UNLESS OTHERWISE SPECIFIED	ORIGINATOR	M. CRISLER	29-MAR-2010
	DRAWN	J. CATALANELLO	01-APR-2010
±	±	CHECKED	NOT CHECKED !!!
1. BREAK ALL SHARP EDGES MAX.	APPROVED	USED ON	
2. DO NOT SCALE DRAWING.	MATERIAL		
3. DIMENSIONS BASED UPON			
4. MAX. ALL MACH. SURFACES			
5. DRAWING UNITS: ✓			
 FERMI NATIONAL ACCELERATOR LABORATORY UNITED STATES DEPARTMENT OF ENERGY			
MECHANICAL/DETECTORS COUPP BUBBLE CHAMBER COUPP-2L PIPING & INST. DIAGRAM			
SCALE	DRAWING NUMBER	SHEET	REV
	9213.400-MC-466868	1 OF 1	
CREATED WITH : Ideas12NXSeries		GROUP: PPD/MECHANICAL DEPARTMENT

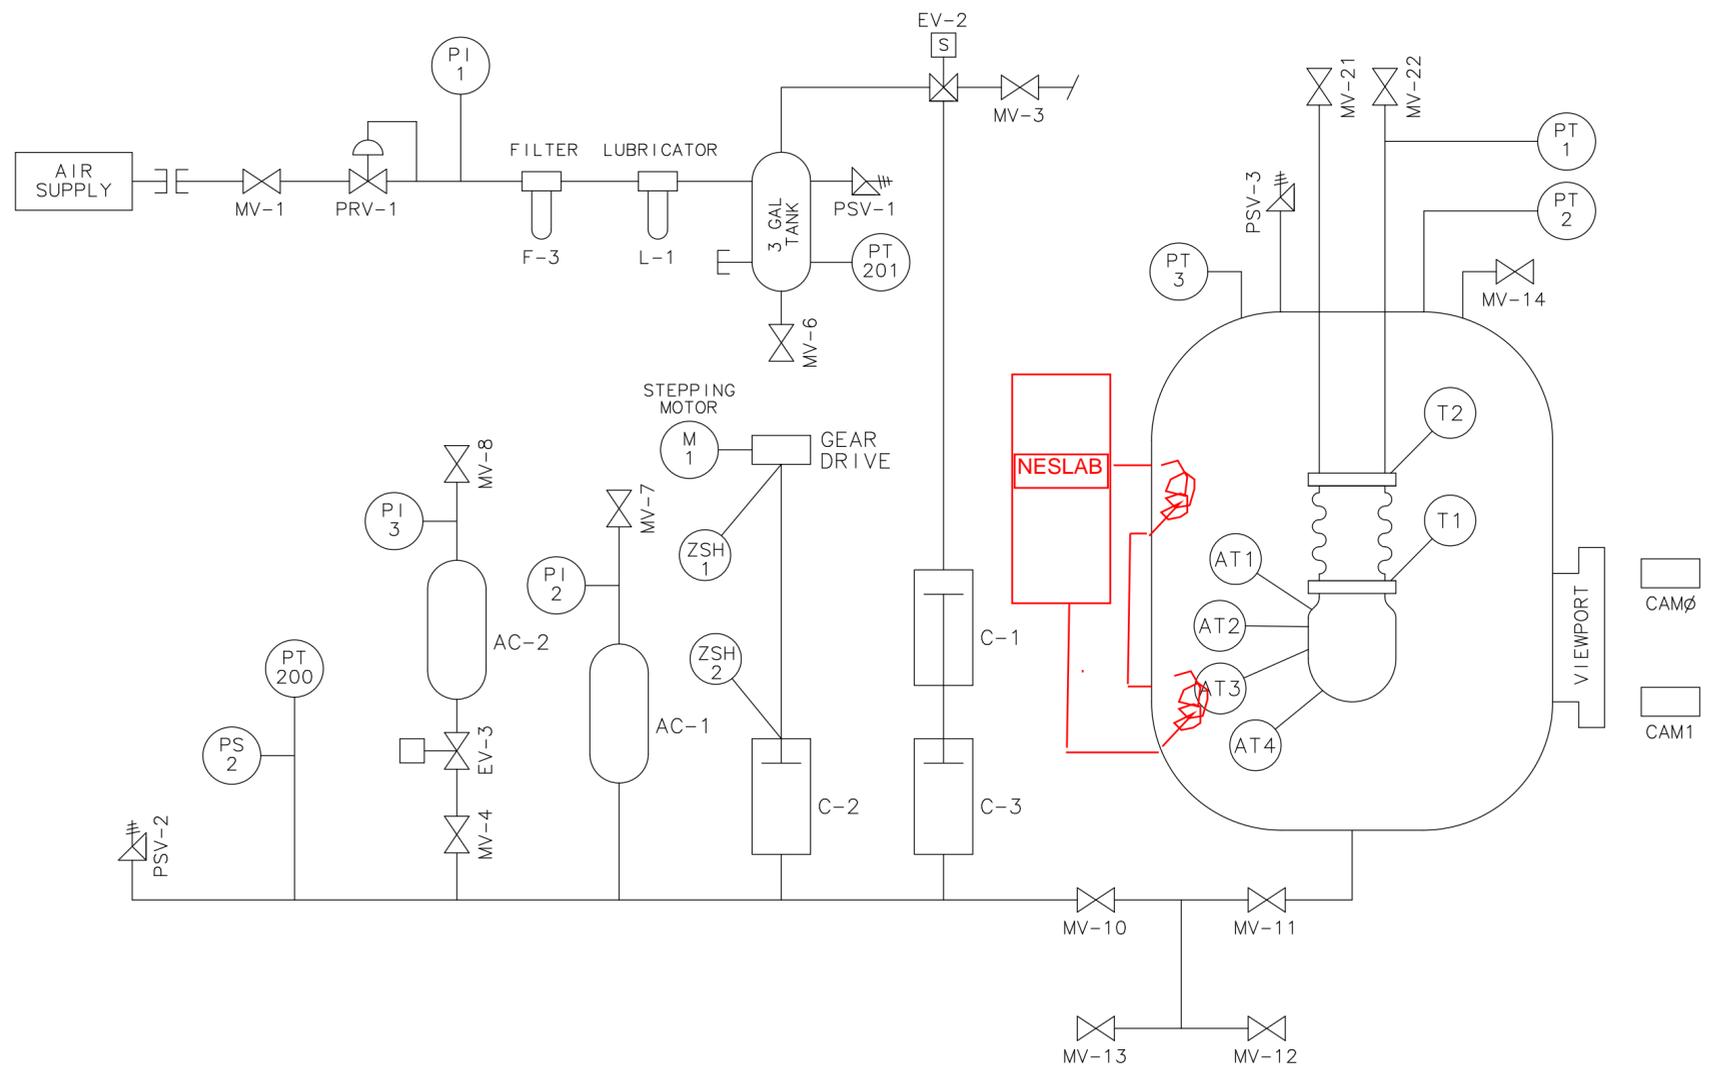
This drawing doesn't include the heater/chiller coils at the top and bottom of the pressure vessel. (my bad...) If is not checked at the MD end and is not released.
